Access Compliance Report

Public Rights-of-Way

(Curb Ramps)

Intersection ID: 29255	Main Street: TRACY_GLENN_CT	Cross Street: AUSTIN_DEKOTA_DR	Location: E
ADA ID: 6AFAE45A013D	Ramp Type: Perp	Initial Pass/Fail: Pass	Overall Compliance: No
Severity Score: 20			
Codes/Mitigation Info/Possible Solution		Field Measurements/Component Compliance

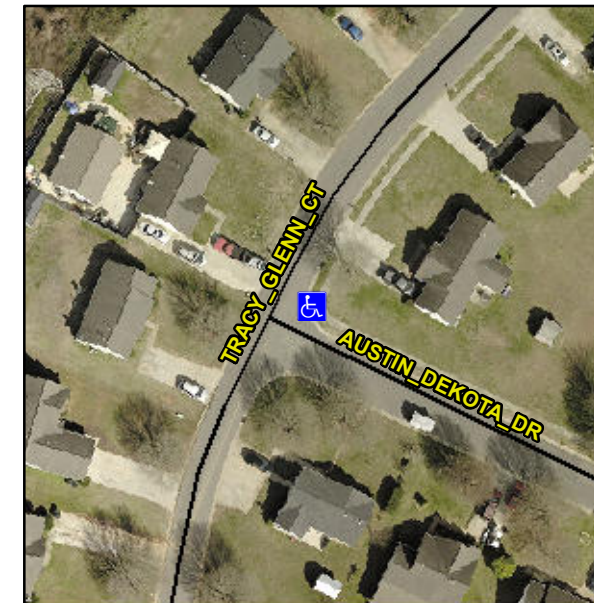
Not Found, R304.2.1, R304.2.2-Perp, R304.3.2-Para, R304.5.3, R305

Compliance	Description	Data	Compliance	Description	Data
N/A	Ramp Length (in)	89.0	Yes	Ramp Slope (%)	5.8
Yes	Ramp Width (in)	60.0	Yes	Ramp XSlope (%)	1.7
N/A	Flare Type LT	Sloped	N/A	Flare Type RT	N/A
N/A	Flare Slope LT (%)	4.9	Yes	Flare Slope RT (%)	1.4
N/A	Flare Traversable LT?	Yes	N/A	Flare Traversable RT?	Yes
No	Landing Length (in)	N/A	No	DWS Provided?	No
No	Landing Width (in)	N/A	N/A	DWS Contrast?	No
No	Landing Slope (%)	N/A	N/A	DWS Length (in)	N/A
No	Landing X Slope (%)	N/A	N/A	DWS Full Width?	No
N/A	Landing Curb? (Y/N)	No	N/A	DWS Offset (in)	N/A
N/A	Shared Landing?	No			
Yes	Gutter Ponding?	No	Yes	Gutter Slope (%)	4.8
Yes	Gutter Lip Ht (in)	0.0	Yes	Gutter X Slope (%)	1.6
N/A	Painted X Walk1?	No	N/A	Painted X Walk2?	N/A
	X Walk 1 Direction	To W		X Walk 2 Direction	N/A
N/A	X Walk 1 Width (in)	N/A	N/A	X Walk 2 Width (in)	N/A
	X Walk 1 Slope (%)	1.5		X Walk 2 Slope (%)	N/A
	X Walk 1 X Slope (%)	1.8		X Walk 2 X Slope (%)	N/A

N/A	Ramp inside XWalk1?	N/A	N/A	Ramp inside XWalk2?	N/A
	Road Slope (%)	N/A	N/A	Clear Space?	Yes
	Road X Slope (%)	N/A	N/A	Clear Space to XWalk (in)	N/A
Yes	Any Obstructions?	No	Yes	Storm Grate/Utility Hazard?	No
	Obstruction Type			Storm Grate/Utility Type	
		N/A			N/A
			Yes	Surface Condition? (G/P)	Good

Remove & Replace Entire Ramp.
